EVALUATION OF PROPOSED PANEL CLOSURE MODIFICATIONS AT WIPP

Environmental Evaluation Group
New Mexico

December 2001

REVIEW OF PANEL CLOSURE BULKHEAD ENHANCEMENTS
WASTE ISOLATION PILOT PLANT (WIPP)

Figure 1. Exhaust drift longitudinal cross section through panel closure bulkhead

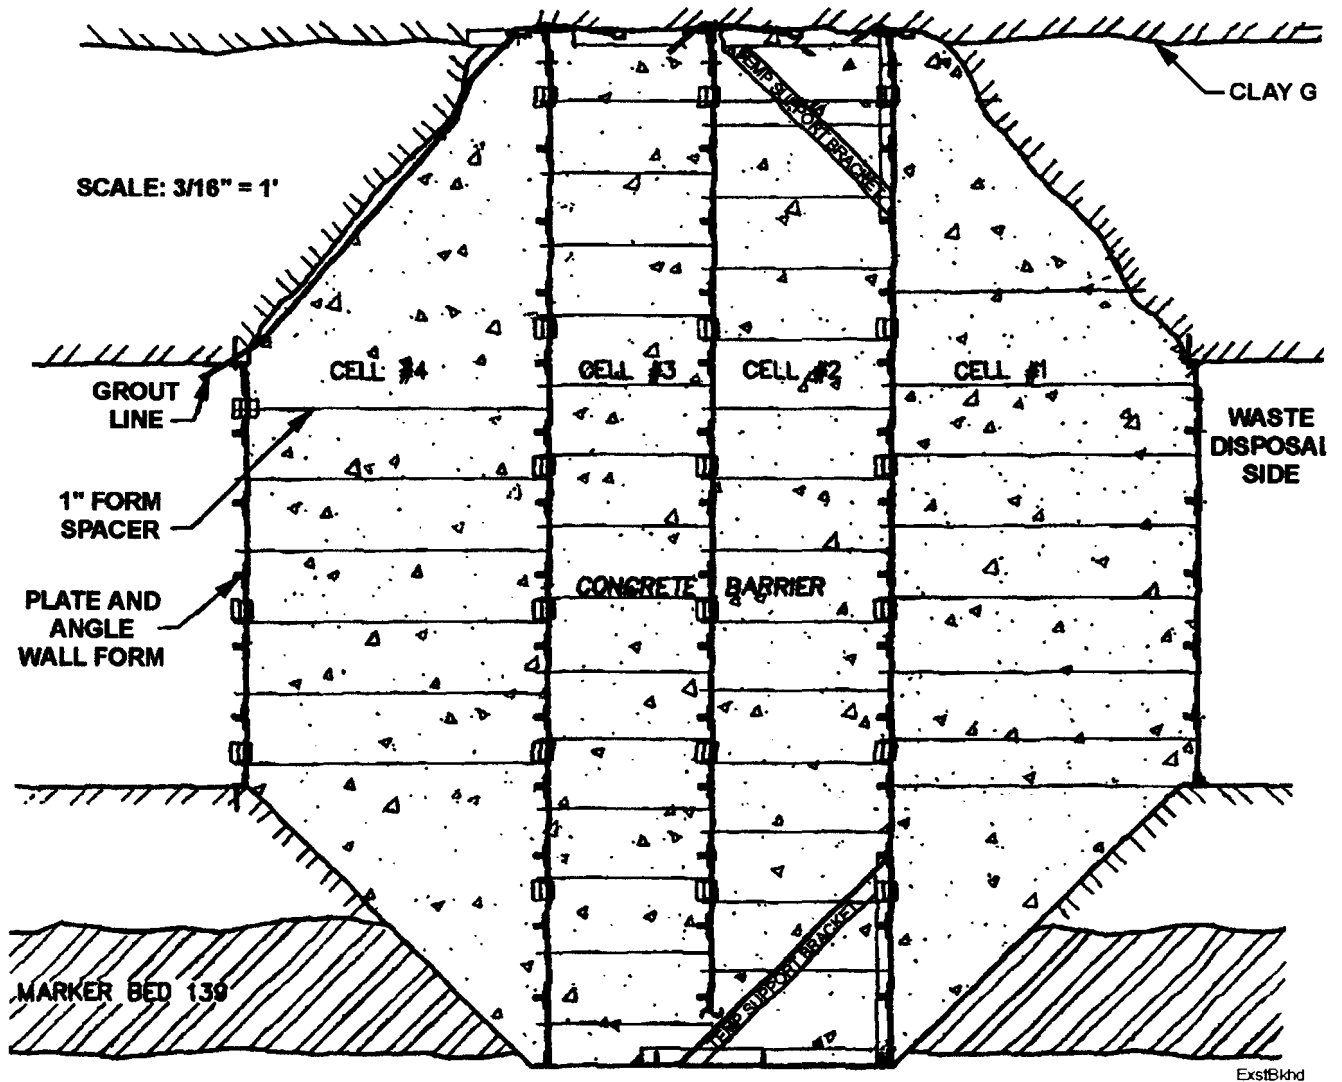
The panel closure bulkhead design (Figure 1 and Figure 10) is not a monolith because it is planned to be built using four

cells. The steel forms will restrain the concrete pumped into each cell until the initial set, which will take approximately 4 hours (Figure 13). Most water retaining bulkheads (Figure 4) are designed and constructed as monolithic, i.e. continuous, pours without cold joints or interior form walls. Figure 14 provides a longitudinal cross section of the reinforced concrete American Tunnel Bulkhead #1, designed to resist a 1550-ft head (670 psi) and supporting 1010-ft (438 psi). Note the waterstops on the bypass pipe and the grout holes drilled through the concrete to low-pressure grout the roof and rib contact between the 11,000 psi compressive strength latite porphyry and the 3,000 psi concrete.

Some multi-cell bulkheads have been constructed when construction problems or emergencies required. At the Summitville Mine a second 20-ft long cell was added when water loss through the 129 psi compressive strength altered latite porphyry and over the initial 6.5-ft long Chandler Adit bulkhead became excessive. At the West Driefontein Mine, in response to a 67,000 gpm water inrush, a three cell bulkhead was progressively constructed on the 12-Level, the initial "temporary" sand and cement bag diversion plug, followed by a 15-ft long thickening bulkhead against the "temporary" plug and the final 60-ft long sand-concrete extension bulkhead. At the Rocanville Mine, in response to a 6,250 gpm brine inrush into the potash mine, an 87-ft thick five cell bulkhead was constructed, an initial 8-ft thick bulkhead, a 16-ft thick second cell, a 25-ft thick third cell and a final 37-ft thick cell (Figure 15). In every case, the cell forms were externally supported and the internal bulkhead forms were stripped before constructing the subsequent cell. The planned four cell panel closure bulkhead construction would not provide a monolithic, i.e. uniform and continuous, bulkhead but could contain as many as three interior steel form walls supported during filling by the form spacers.

Penetrations through a water retaining bulkhead are normally minimized, whenever possible, because they represent potential leakage paths through bulkheads. Essential penetrations, such as bypass and sampling and pressure monitoring pipes, include waterstops to assure no leakage along the penetrations. The planned 4 cell panel closure bulkhead (Figure 1) includes the use of longitudinal 1-in diameter form spacers, which also support the facility side plate and angle form wall until the concrete sets. Figure 5 indicates 55 form spacer penetrations across Cell #2 and Cell #3. Figure 6 indicates 22 form spacer penetrations across Cell #1 and Cell #4. Multiple potential flow paths are apparent across the individual cells. If not removed after the cell is filled, the steel plate and angle forms provide multiple potential leakage paths between form spacers in adjacent cells. The bond strength between the steel plates and the concrete is

necessarily low. Even if a way is found to remove the three interior steel form walls, after the concrete has set in each cell, a smooth surfaced cold joint will still be present between cells.

The most important of the specific enhancements proposed, allowing flexibility in the bulkhead forming practices is troubling because the planned bulkhead design contains multiple potential leakage paths within cells, between cells and through the panel closure bulkheads. It is recommended that the panel bulkhead specifications:

- 1) provide an incentive for the contractor to minimize the number of cells (preferably to one),
- 2) require that each cell be filled as a continuous monolithic concrete pour,
- 3) require the contractor support the fluid concrete in all cells with external structures,
- 4) require the contractor to remove the support structures and forms between internal cells,
- 5) provide for a rough form surface between internal cell walls, (possibly with a layer of burlap),
- 6) assure that some grout points are located at the roof concrete/rock salt contact and
- 7) prevent the use of all internal form spacer supports.

Figure 2. Explosion-isolation masonry wall bulkhead

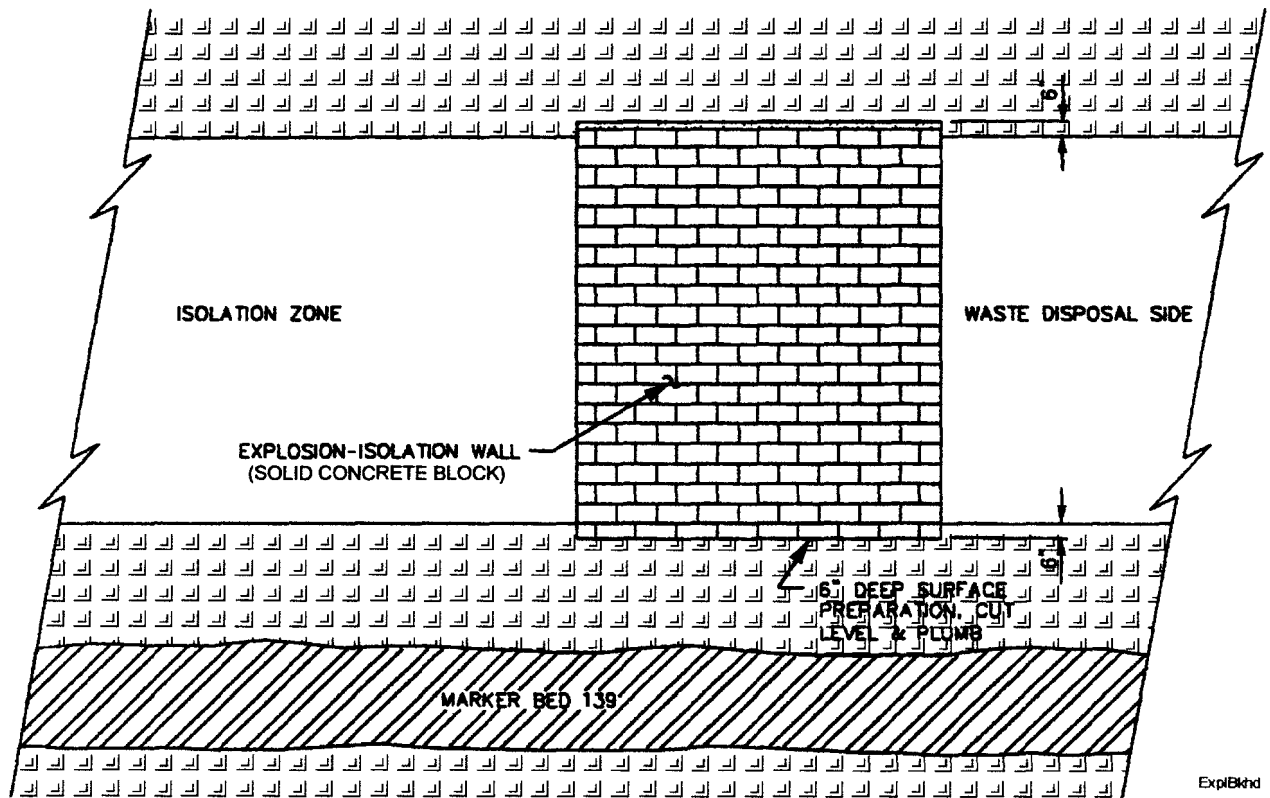
The 12-ft thick explosion-isolation masonry walls for the Intake Drift and the Exhaust Drift (Figure 2) are planned to be built with solid concrete blocks (3,500 psi) mortared with cement and hitched 6-in into the roof, ribs and floor. The explosion-isolation masonry wall is apparently designed to resist the 480 psi methane explosion pressure during the six months to one year of panel bulkhead construction.

The ability of the planned explosion-isolation masonry walls to resist the 480 psi methane explosion pressure was conservatively checked using the water impoundment bulkhead design method (Abel, 1998). Table 1 presents the results of this analysis. The calculations for the Intake Drift are presented in Appendix C and for the Exhaust Drift in Appendix D. The results of this analysis predicts that the planned 12-ft thick explosion-isolation masonry walls would not be capable of resisting the 480 psi design methane explosion pressure. The predicted failure of the explosion-isolation wall is indicated on Figure 12. In the Intake Drift, the thickness of an explosion-isolation masonry bulkhead would have to be approximately 20-ft to contain the 480 psi methane explosion pressure and in the Exhaust Drift approximately 15-ft.

Figure 3 presents the predicted 17+ year methane concentration time interval between cessation of panel ventilation and the methane concentration reaching the minimum 5% lower explosive limit. The predicted methane concentration should not exceed approximately 0.25% during a one-year panel closure bulkhead construction period. Therefore, a methane explosion should not be possible, and an explosion-isolation masonry wall not necessary.

The planned 12-ft thick explosion-isolation masonry walls should not be built. The methane concentration will take more than 17 years to rise to the 5% lower explosive limit after stopping panel ventilation. If built, the planned 12-ft thick explosion-isolation masonry walls would probably be incapable of resisting the design 480 psi methane explosion pressure.

Figure 10. Optional designs for panel closure systems

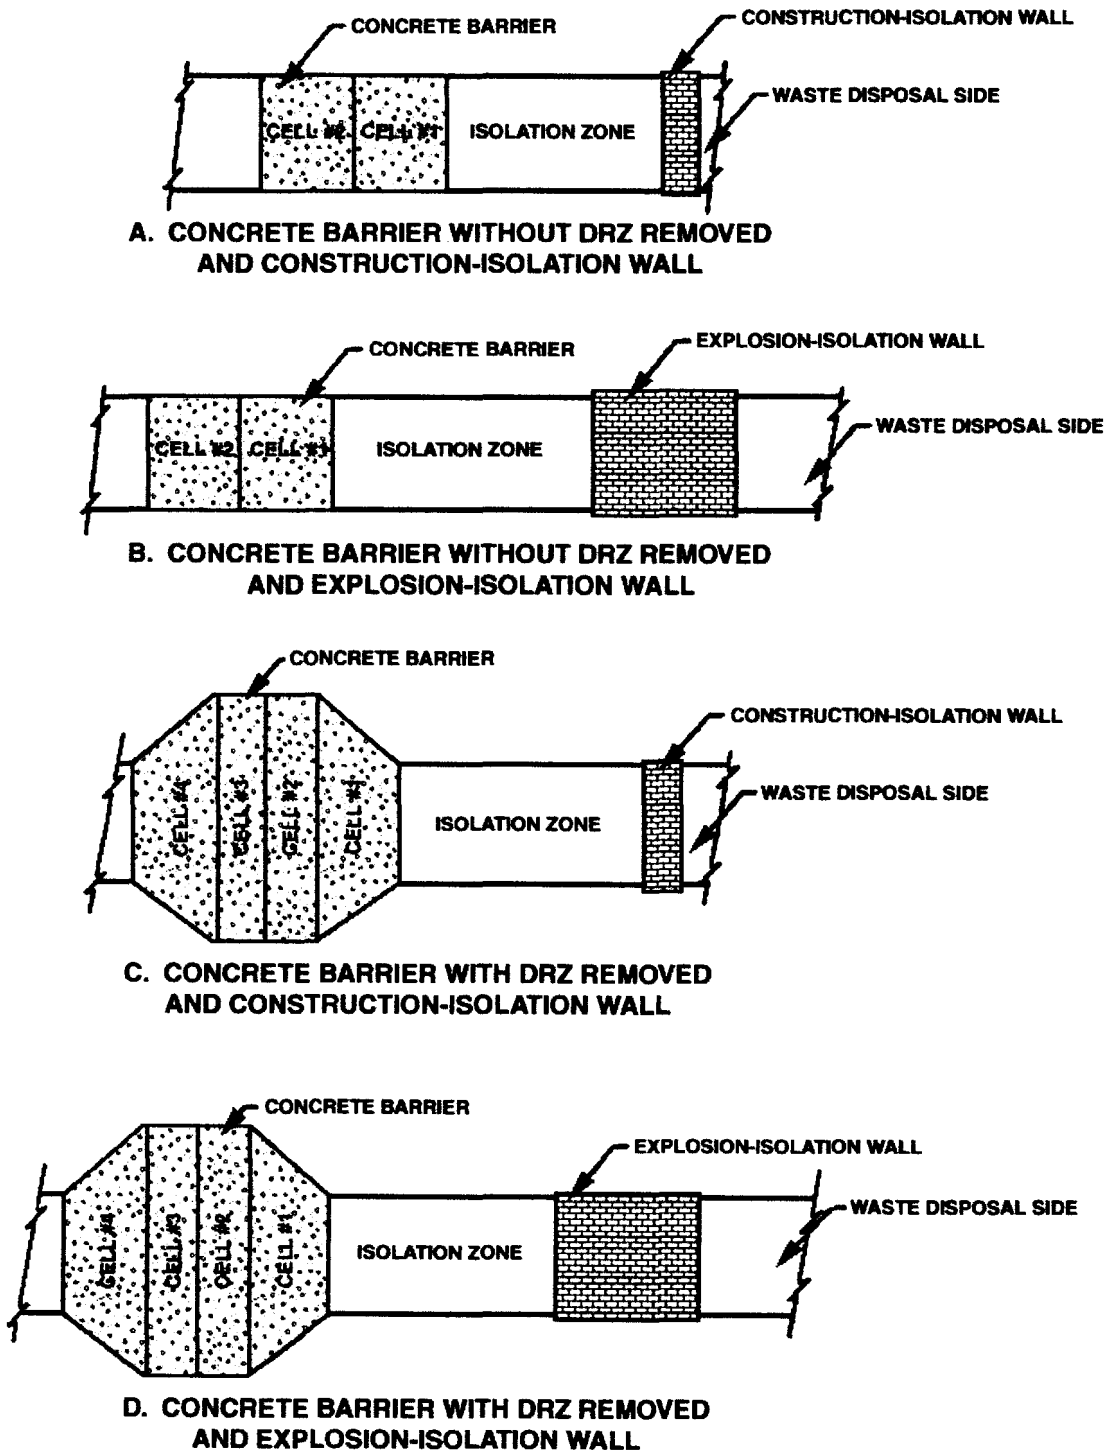
Parallel panel closure bulkheads would probably be successful in resisting the potential applied pressures, Options A and B on Figure 10. However, the progressive deterioration of the adjacent rock salt and anhydrite and clay layer bed separations suggests that the two-way tapered bulkhead will assure the long term functioning of airtight panel closure bulkheads.
